**REQUEST FOR TENDERS
AUSTRALASIA OUTDOOR AVIARY
TZC T 41 (2022-08)
ADDENDUM #1**

**RESTORATION OF
AUSTRALASIA OUTDOOR
AVIARY PROJECT**

1 PROPOSED ELECTRICAL FEED LINE
SCALE: 1/8" = 1'-0"

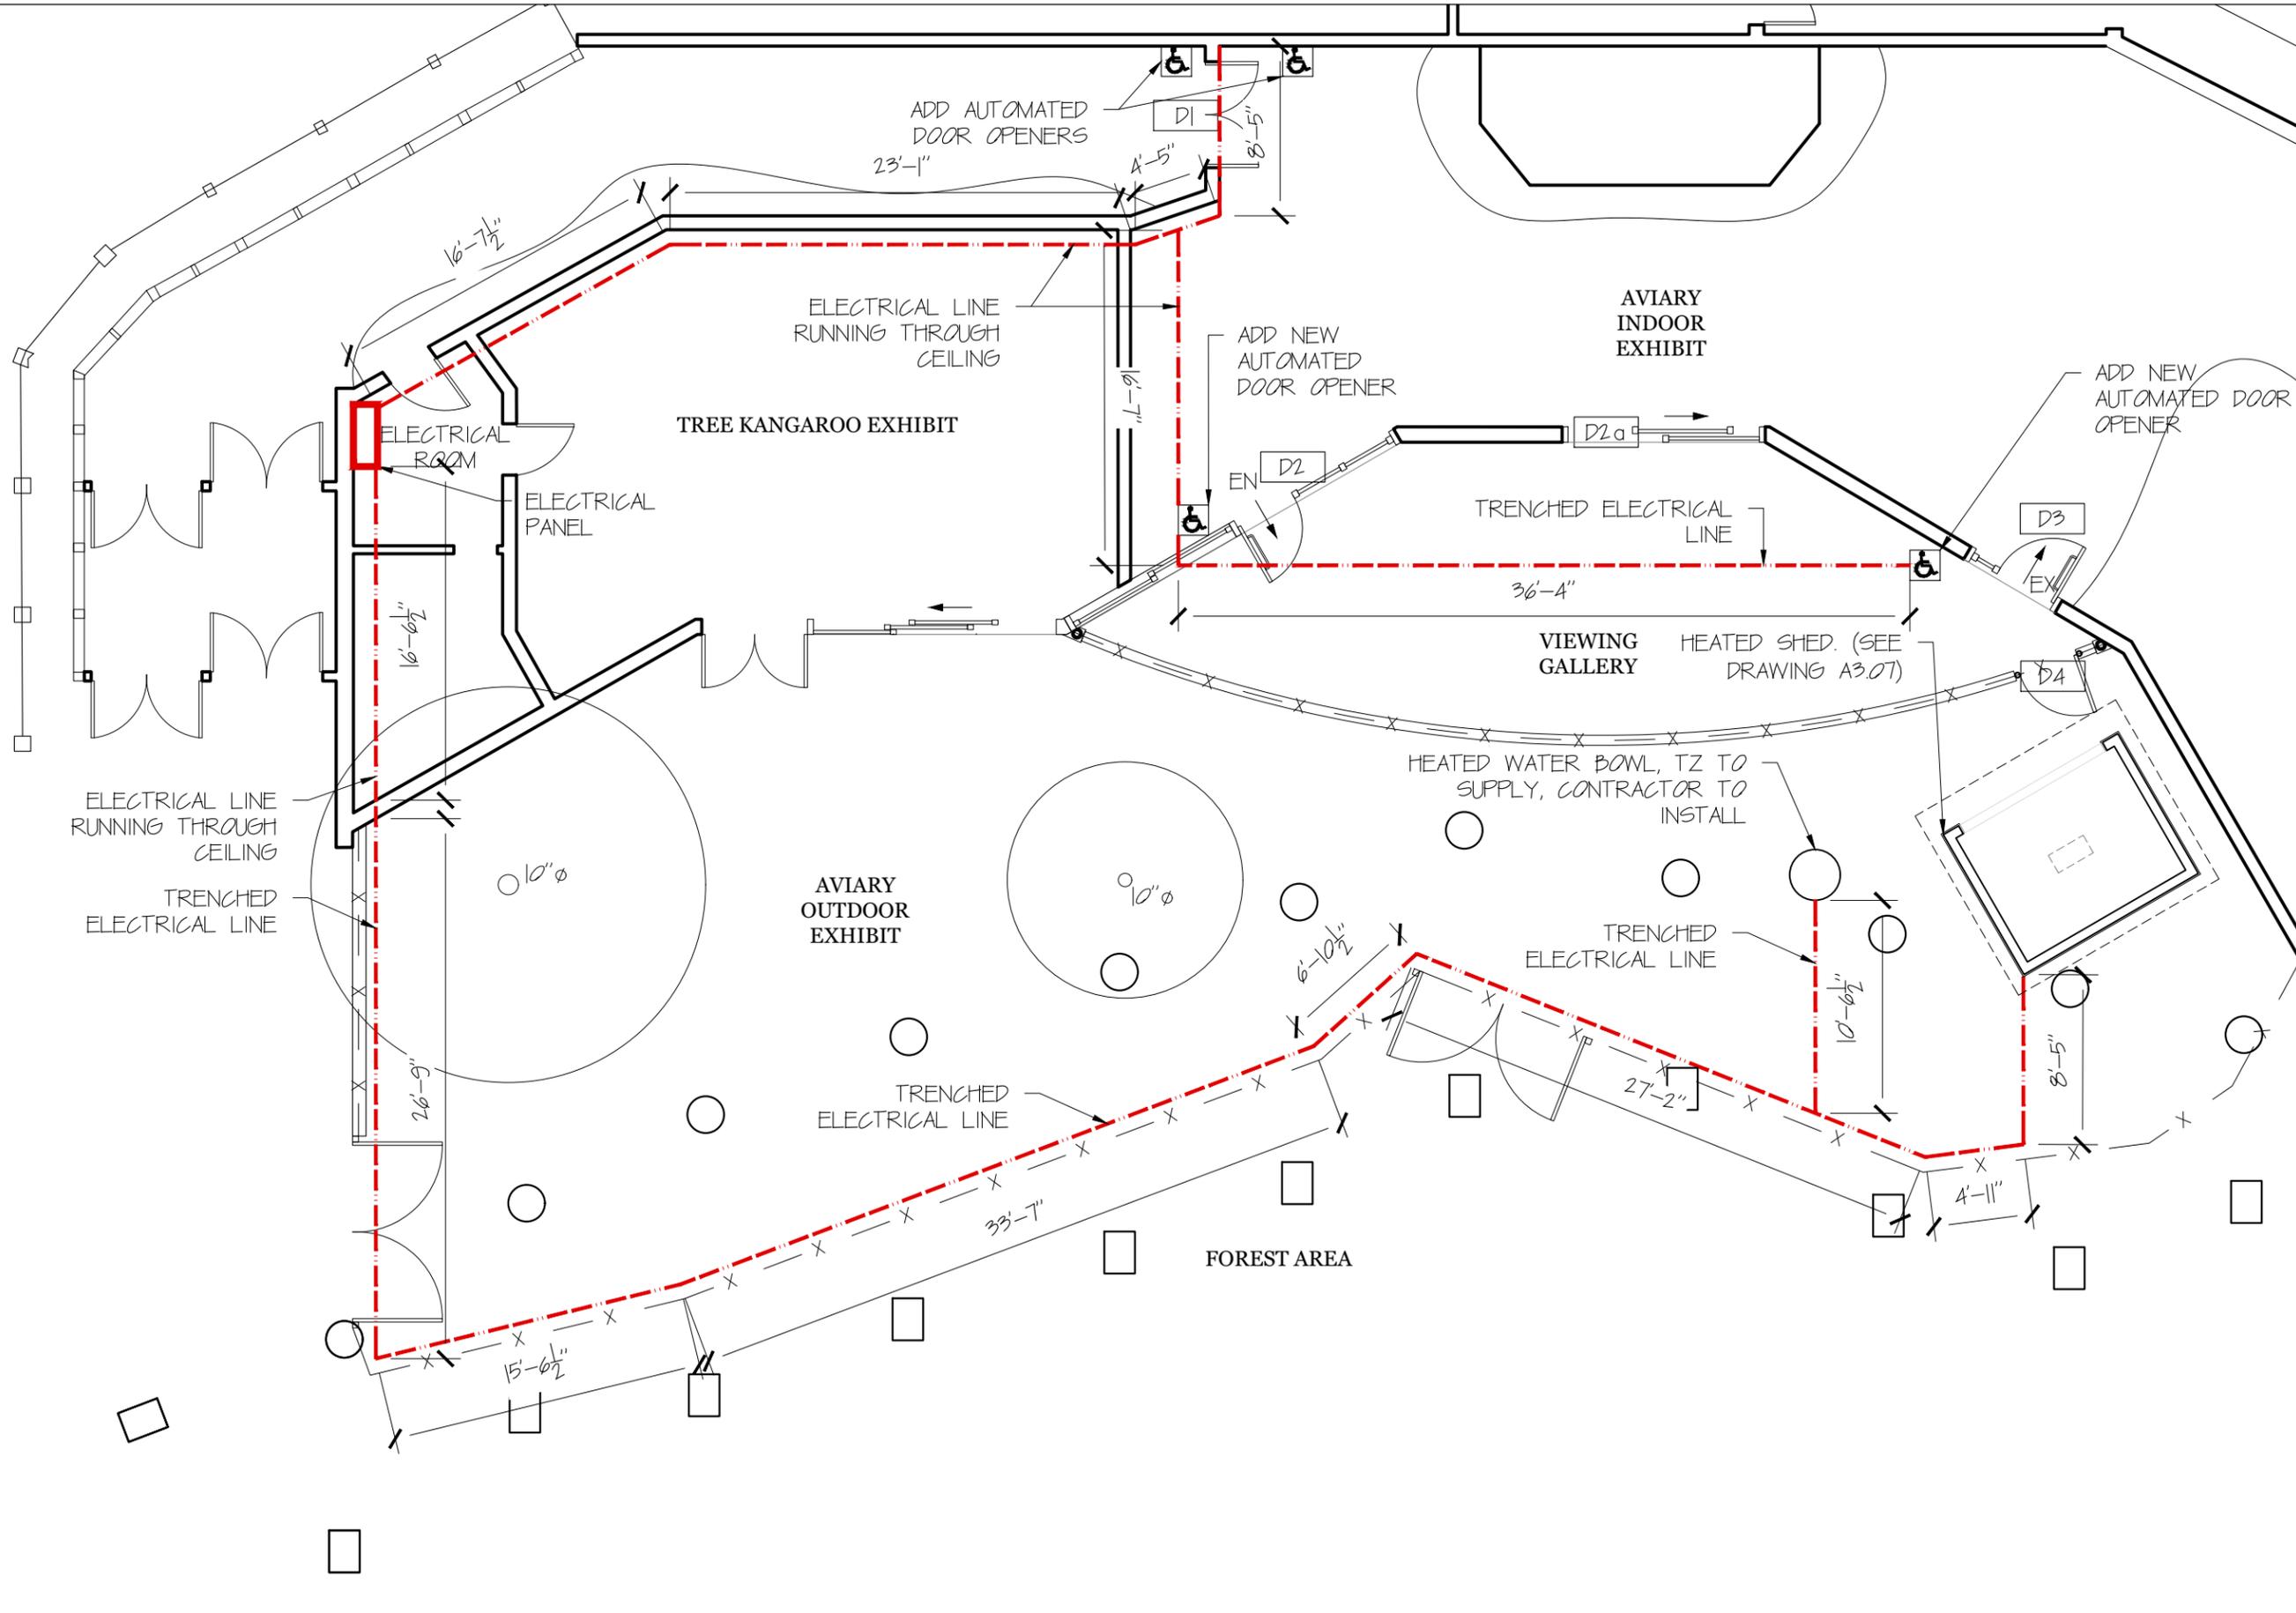
Contractor to run electrical servicing through conduit along the outside perimeter of the aviary to the heated shed. See drawing A3.01 and A3.06.

- 7. Question:** Can you please illustrate on the drawings the routing of the electrical connections for all the new elements (automatic door closers, shed heaters, etc.)

Answer: Please see attached – DRAWINGS – AUSTRALASIA OUTDOOR AVIARY (2022-08-24) ADDENDUM 1.
